UNITED STATES PATENT AND TRADEMARK OFFICE

APPLICATION NO.	FILING DATE	FIRST NAMED INVENTOR	ATTORNEY DOCKET NO.	CONFIRMATION NO.
10/576,420	04/19/2006	Shunpei Yamazaki	740756-2955	9417
22204	7590	12/26/2007	EXAMINER	
NIXON PEABODY, LLP			TRAN, TONY	
401 9TH STREET, NW			ART UNIT	PAPER NUMBER
SUITE 900			2818	
WASHINGTON, DC 20004-2128				
MAIL DATE		DELIVERY MODE		
12/26/2007		PAPER

Office Action Summary	Application No.	Applicant(s)
	10/576,420	YAMAZAKI ET AL.
	Examiner Tony Tran	Art Unit 2818

DETAILED ACTION

FIG. 22A

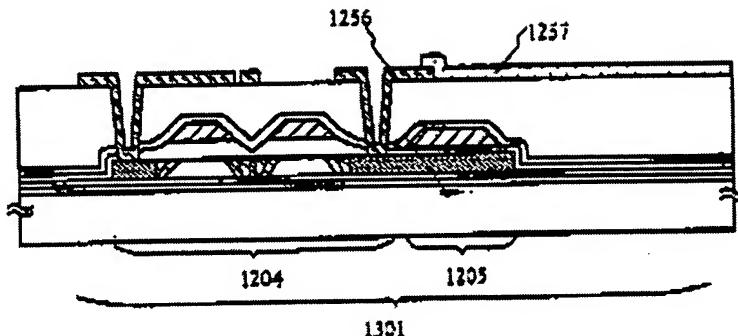
Regarding Claim 1, Arao, embodiment 7, FIGS. 22A-22D does disclose a liquid crystal display device comprising:

a thin film transistor (1204, FIG. 22A, col. 27, lines 47-49);
a projection (P, FIG. 22B {as shown above}, note that P included 1256b-c) over a drain electrode (1256a, col. 27, lines 45-50) of the thin film transistor (1204); and a pixel electrode (1257, col. 27, lines 44-46) connected to the film projection (P), wherein the projection has a stacked structure (1256b-c, col. 27, lines 30-40).

FIG. 22B

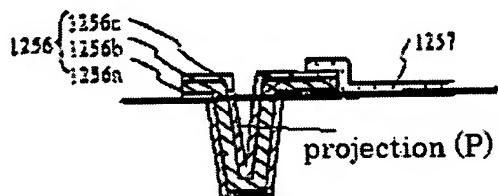
Regarding Claim 4, Arao, embodiment 7, FIGS. 22A-22B further teaches the liquid crystal display device according to claim 1, wherein at least one of the drain electrode

(1256a, FIG. 22B), and the projection (P) contains one selected from the group consisting of titanium, and aluminum (col. 27, lines 34-41).

FIG. 11

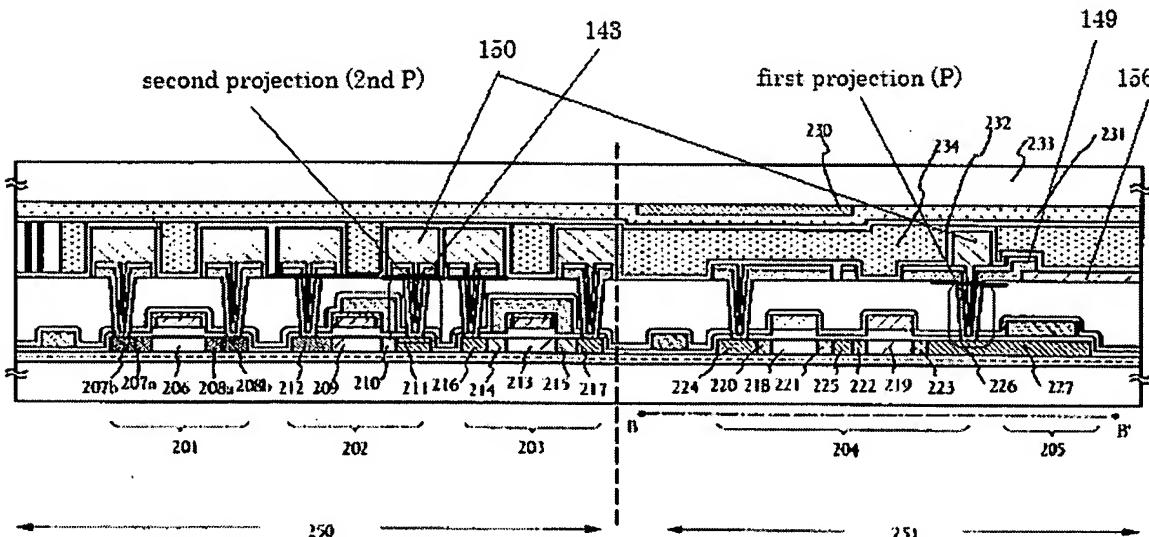
Regarding Claim 13, Arao, embodiment 1, FIGS. 1-6, & 11 teaches A liquid crystal display device comprising: a pixel portion (251, FIG. 11, col. 12, lines 25-30) including a thin film transistor (204, col. 12, line 26), a first projection (P, FIG. 11, [as shown above], note the P included the two layers: upper top layer 149 and a cutout portion of 150, col. 12, lines 65-67) over a drain electrode (lower bottom layer 149, FIG. 5A, col. 12, lines 10-12) of the thin film transistor (204) and a pixel electrode (156, FIG. 5A, col. 12, line 9) connected to the first projection (P); and a terminal portion (250, col. 12, lines 25-26) including a wiring (lower bottom of wiring 143, col. 12, lines 10-12), a second projection (2nd P, note that 2nd P included the two layers: upper top of 143 and a cutout portion of 150) over the wiring (lower bottom of 143) and a terminal electrode (upper top of wiring 143) connected to the second

projection (2nd P), wherein each of the first projection (P) and the second projection (2nd P) has a stacked structure.

Regarding **Claim 14**, Arao, embodiment 1, FIGS. 1-6, & 11 teaches the liquid crystal display device according to claim 13, wherein a gate electrode (122, FIG. 2C, col. 10, lines 54-57) of the thin film transistor (204) is formed over an area (218, 219, FIG. 11, col. 12, lines 50-52).

Regarding **Claim 16**, Arao, embodiment 1, FIGS. 1-6, & 11 further teaches the liquid crystal display device according to claim 13, wherein at least one of the gate electrode (119, FIG. 2C, col. 10, lines 20-25), the drain electrode (149), the first projection (P), and the second projection (2nd P, col. 11, lines 53-60) contains one selected from the group consisting of gold, silver, copper, platinum, palladium, tungsten, nickel, tantalum, bismuth, lead, indium, tin, zinc, titanium, and aluminum.
